REPLACES	28L073	4-10-43	.269
			CALC WT

NAME	JOURNAL - FLOAT	OPP HAND
	RETR. SCREW - INBOARD	DWS
		B
		28L073
CONSOLIDATED AIRCRAFT CORP. W. SAN DIEGO CALIF		SIZE

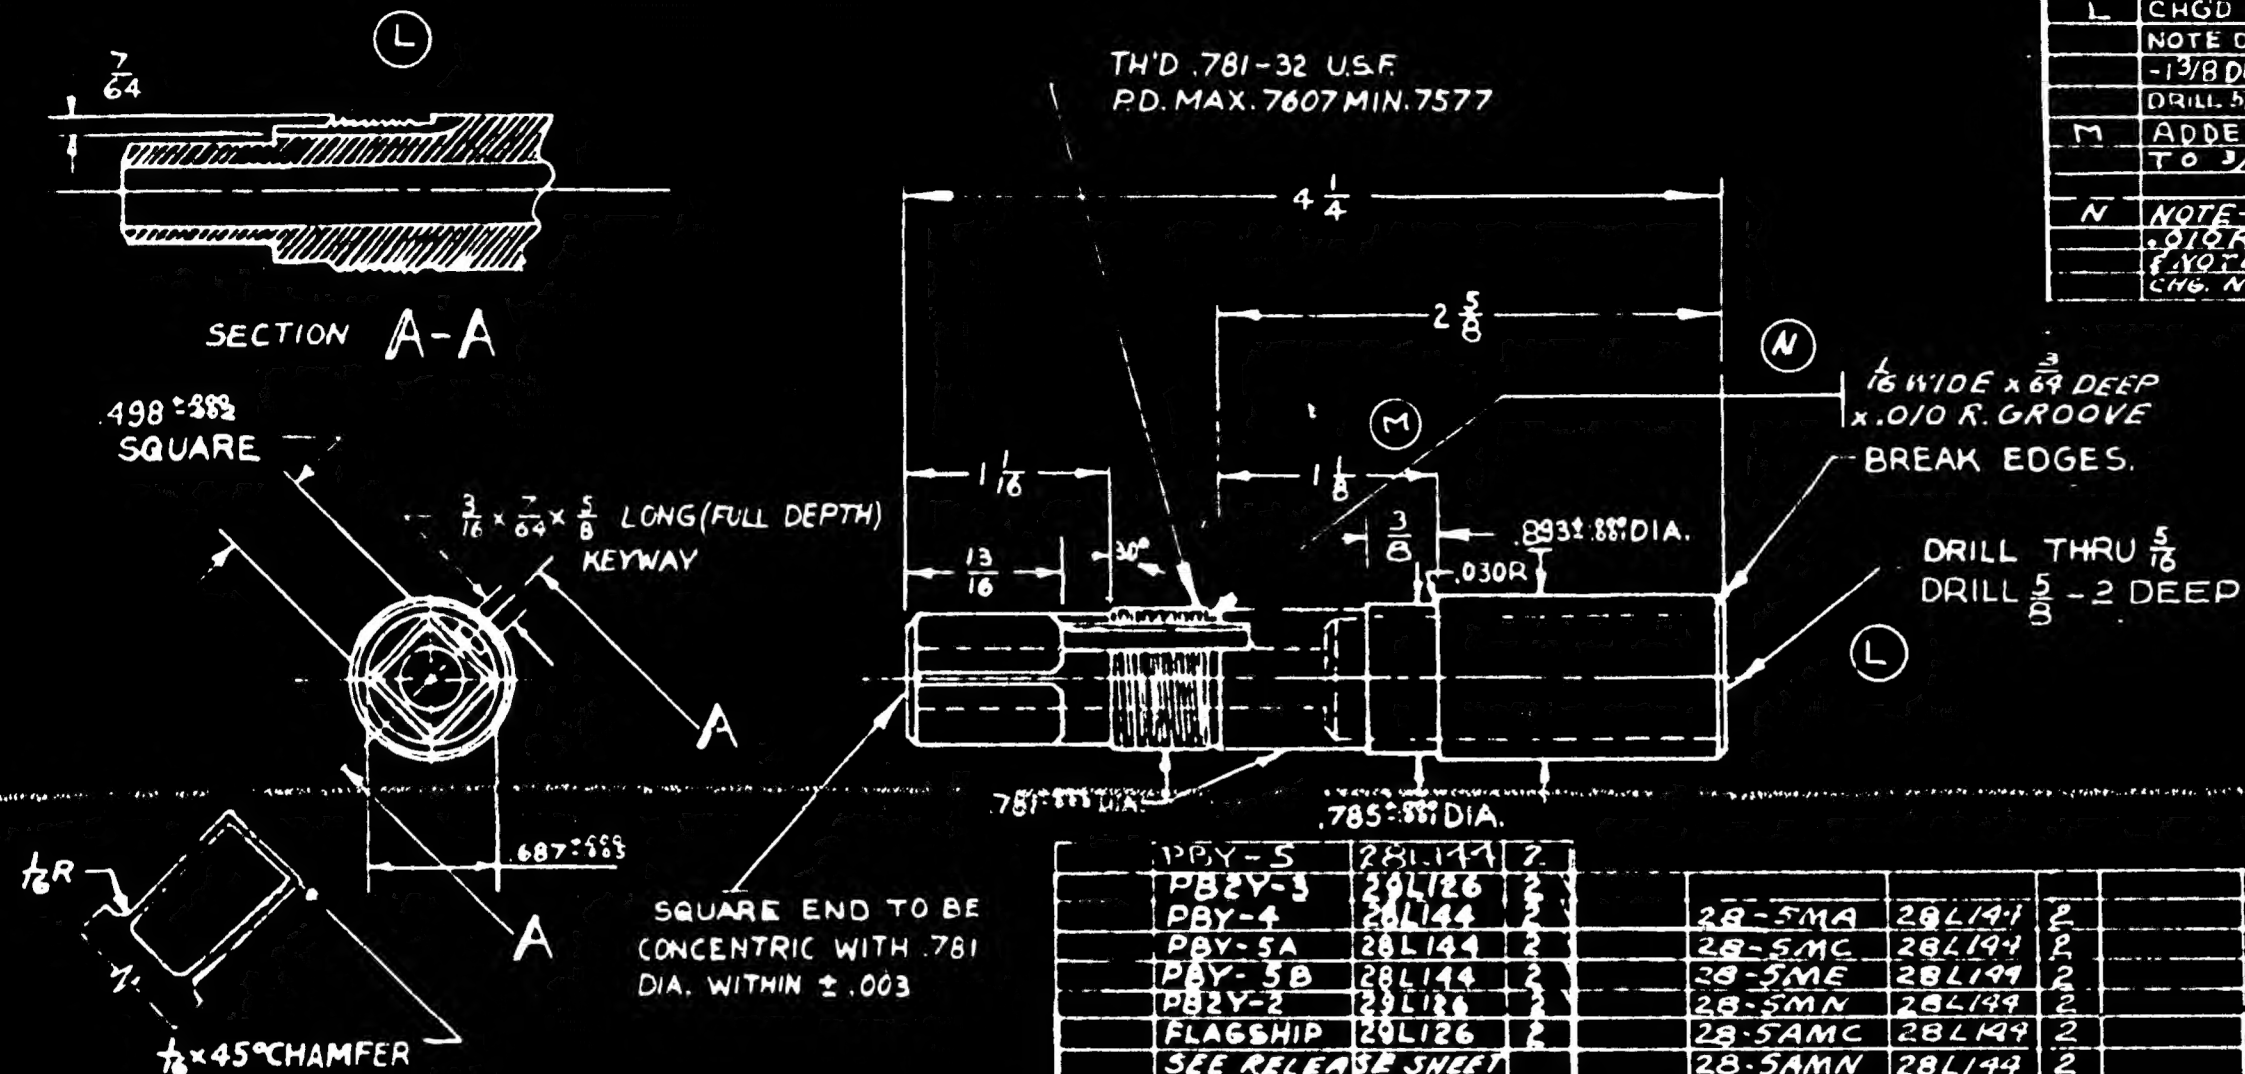
LET	ALTERATION	DATE	BY
K	REDRAWN & REVISED	10-17-43	ARNHYN
	ADD. MAT'L NOTE: NO WT. CHG.	10-17-43	ARNHYN
L	CHGD INSIDE DRILLING REMOVED		
	NOTE DRILL 1/2-3 1/4 DEEP DRILL 23/32		
	-13/8 DEEP DRILL 5/8-2 DEEP WAS		
	DRILL 5/8-23/8 DEEP NEG. VITCHG	5-15-43	MOORE
M	ADDED 1/32 R. FULL RADIUS		
	TO 3/64 GROOVE		
	WT. CHG. NEG.	5-21-43	WHIT
N	NOTE-1 1/16 WIDE x 3/64 DEEP x		
	.010 R. GROOVE REPLACES 3/64 DIA.		
	NOTE 1/32 FULL RADIUS WT.		
	CHG. NEG.	5-26-43	WHIT
